RE: New York City's DEIS for the Gowanus Canal area

20211008 Response to Additonal Comments from EPA.pdf;

The City is doing the design and implementation of the CSO and Canal remedy pursuant to several EPA Superfund orders. **EPA requests that DEP provide responses to the following questions within 30 days of your receipt of this request in order for EPA to assess potential impacts to the Superfund remedy.**

Figure 11-3

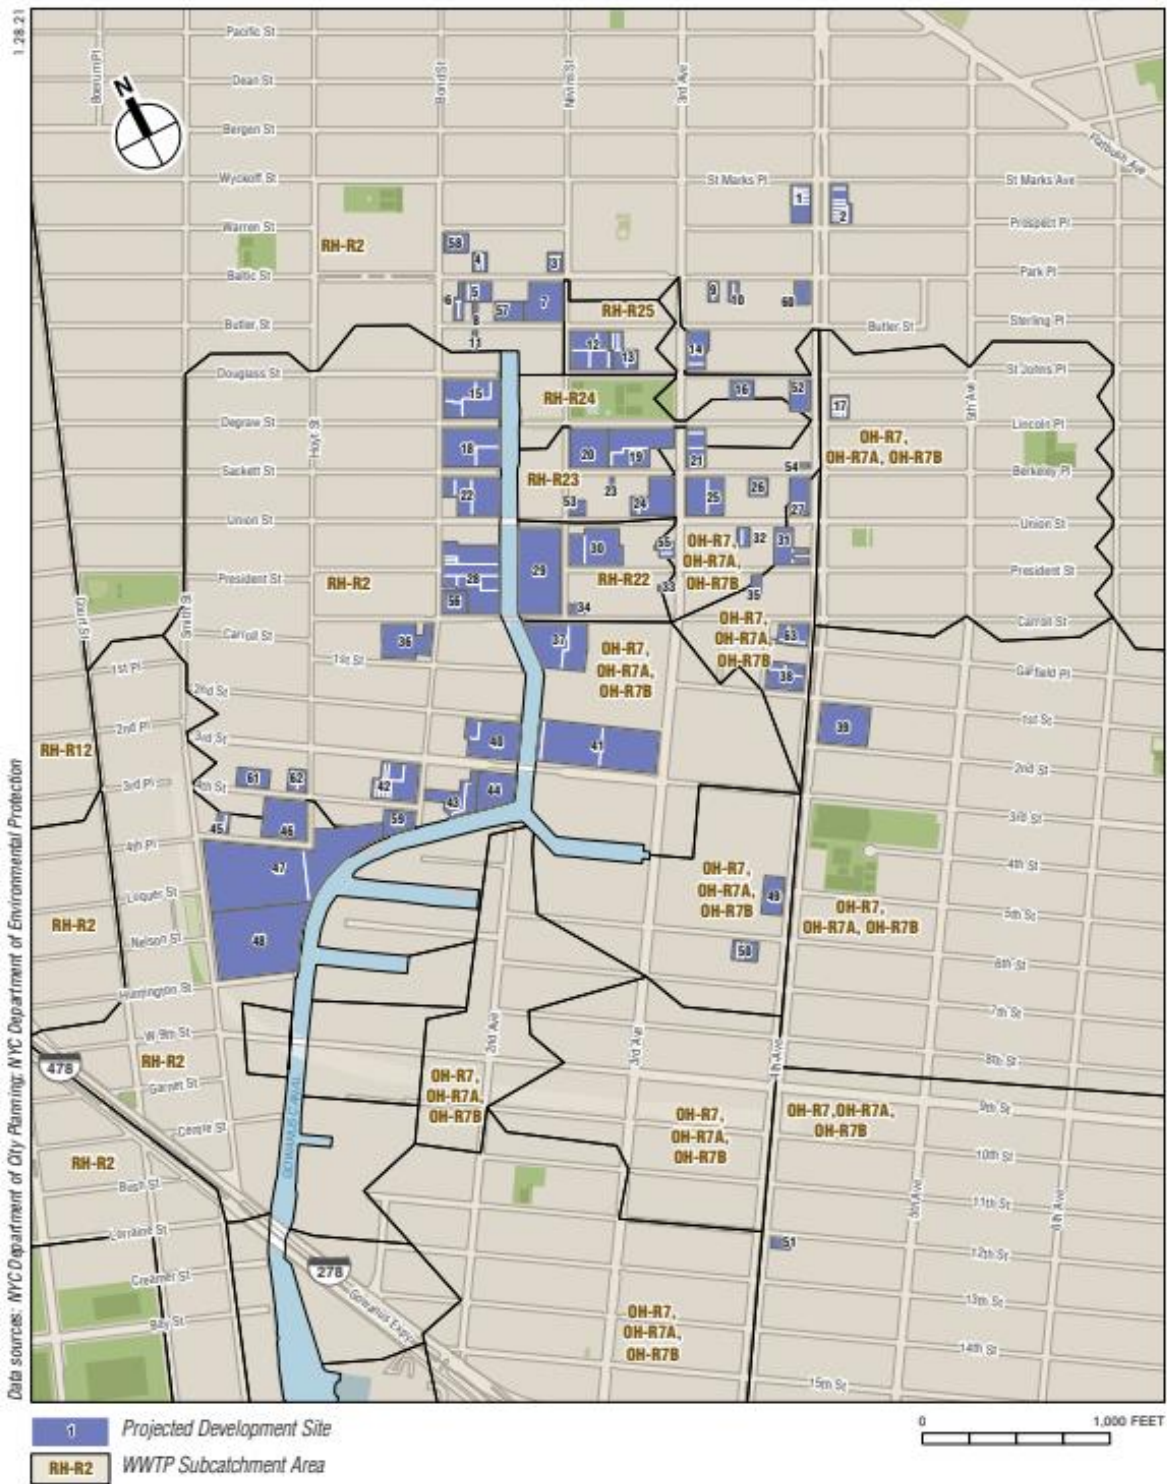
9. Please provide EPA with a map that identifies all the lots in the Gowanus Canal CSO drainage areas that the 2021 Unified Stormwater Rule would apply to, and provide a calculation showing how the application of the Rule to those properties would change the associated CSO outfall's discharge volume.

The 2021 Unified Stormwater Rule (USWR) will apply to all new construction, additions/alterations, and agency projects City-wide. For the rezoning analysis, all projected development sites as determined by the Department of City Planning were modeled as subject to the USWR. Figure 11-3 in Chapter 11 (below) of the EIS shows the projected development sites. Stormwater retention and/or detention practices required by the USWR at these sites were explicitly modeled using approaches consistent with the DEP representation of green infrastructure (GI) in the LTCP models.

It is impossible to provide a hand-calculation of how the application of the USWR at one specific site translates to associated CSO outfall discharge volume for two reasons: (1) reductions in combined sewage, which is the sum of reduced stormwater volume and increased sanitary sewage at a given site, are different for different storms within the typical year; and (2) reductions at site-scale get mitigated as the flow is conveyed through the collection system and the compounding reductions at multiple sites is what ultimately leads to the reduction in CSO observed at an outfall located downstream. Due to these dynamic effects, USWR benefits must be modeled. In general, previous DEP GI modeling efforts, documented in the GI Performance Metrics Report submitted to New York State Department of Environmental Conservation as part of a consent order, provide equivalency rates of about 0.3-0.4 MG of annual CSO reduction per 1 acre of impervious area managed by GI.
